To: All U.S. and Canadian Volvo Retailers
Subject: Service Campaign S29650

Service Campaign S29650: Engine Oil Specification UpgradeREF NO:
TJ 31443.1.4ISSUING DEPARTMENT:
Technical ServiceCAR MARKET:
United States and CanadaPARTNER:
3 US 7510 Volvo Car USAISSUE DATE:
2018-10-26STATUS DATE:
2018-10-26FUNC GROUP:
2100FUNC DESC:
Engine

**Service Campaign S29650: Engine Oil Specification Upgrade
Model Year 2012 S60 Engine Code 62**

Title	Decal	Page	1 (3)
Action	Replacement	Operation number:	98600-2

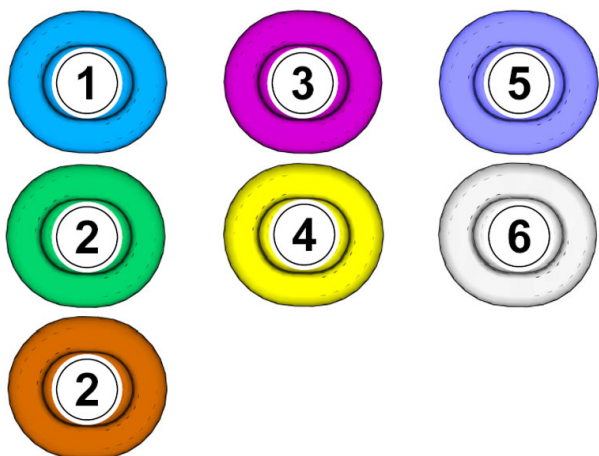
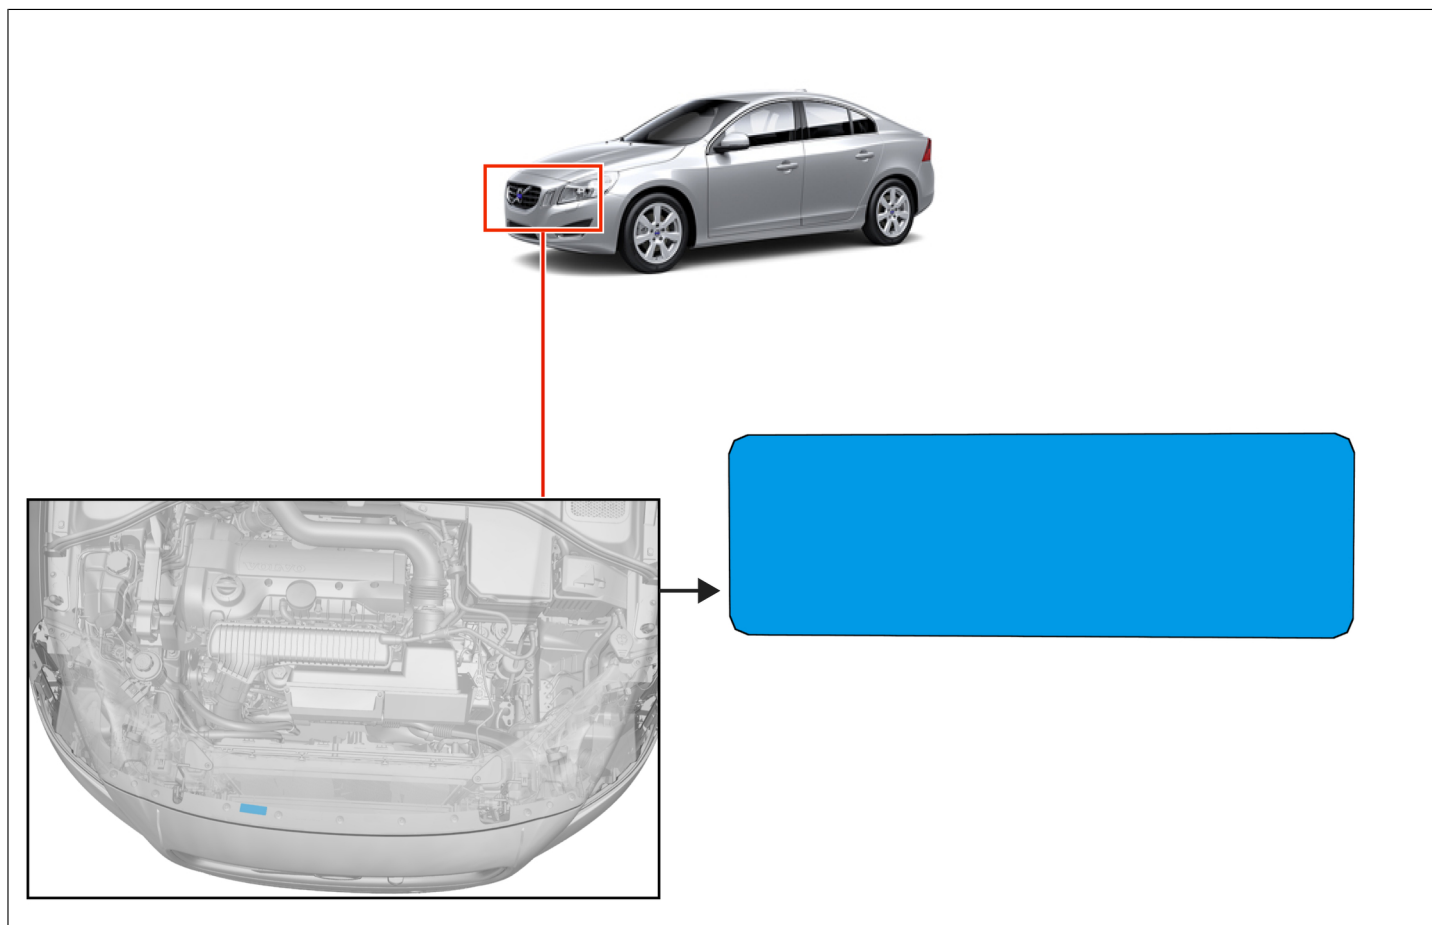
The corrective action is to install an engine oil specification decal in the engine compartment, and update the Owners and Warranty Manuals.

Fit the label in the engine compartment according to the attached instruction.

Caution! Make sure that the surface is clean and free of foreign material.

Fit the decal.

Use: Isopropanol , 31375638

Viscosity chart

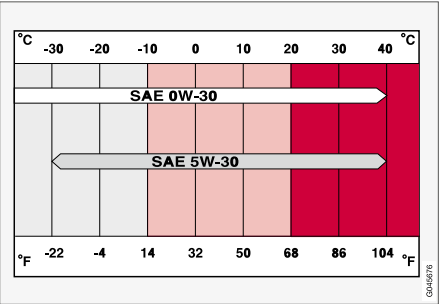
Full synthetic engine oil meeting the minimum ACEA A5/B5 must be used. Lower quality oils may not offer the same fuel economy, engine performance, or engine protection.

SAE 0W-30 oil meeting ACEA A5/B5 requirements is recommended for extreme driving conditions.

Viscosity chart

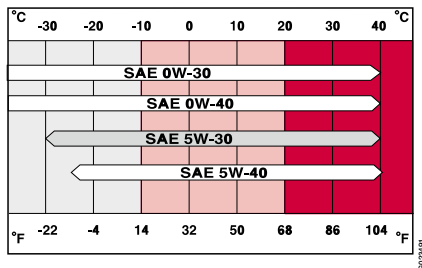
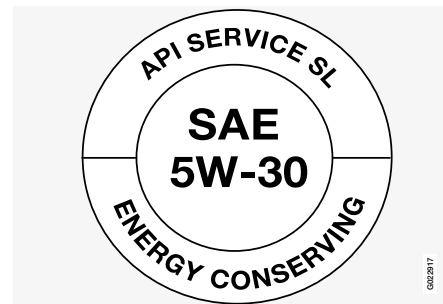
Only full synthetic oil meeting ACEA A5/B5 requirements should be used. Lower quality oils may not offer the same engine performance or engine protection.

Synthetic oils meeting SAE 0W-30 or 0W-40 and complying with oil quality requirements are recommended for driving in areas of sustained temperature extremes (hot or cold), when towing a trailer over long distances, and for prolonged driving in mountainous areas.
